SIB 11 08 21

## Recall 21V-907: Exhaust Gas Recirculation (EGR) Cooler – N57T High Temperature

This Service Information Bulletin (Revision #2) replaces SI B11 08 21 **dated February 2022**.

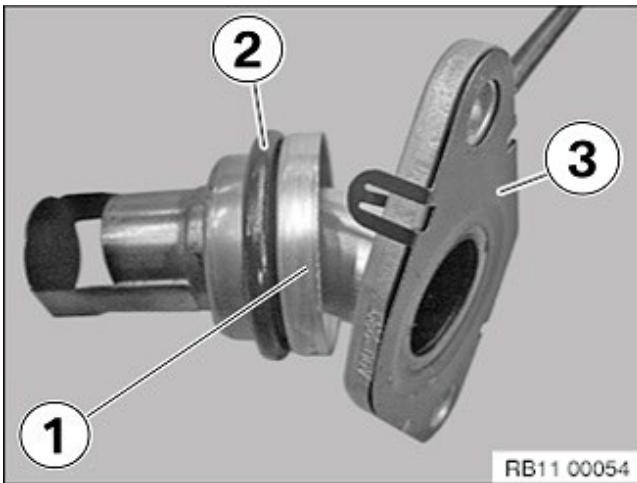
- Remove the EGR pipe from the intake venturi pipe (replace O-ring (2) and gasket (3)).

- Replace the coolant pipe from the Auxiliary EGR cooler to the coolant pump distribution block (1)

- NOTE: The new coolant line PN 11 14 7 827 410 is routed in a different location than the original line (1)

- Inspect and clean (if needed) the EGR pipe. Wear protective equipment (eyes and hands) and clean out the excessive carbon using a degreasing agent and a brush (suitable brushes can be found in wheel brush kit 83 19 2 298 237).
- Reinstall the EGR pipe with new gasket and O-ring before installing the new EGR cooler.

- Install the new EGR cooler following the repair instructions.
- Replace the vacuum hose PN 11 65 8 595 650 (enough hose for two repairs) from the changeover valve to the bypass flap on the cooler (measure the new hose and cut according to the old hose)
- The acoustic cover will be replaced with PN 11 14 8 490 569 (if an acoustic covered was installed)
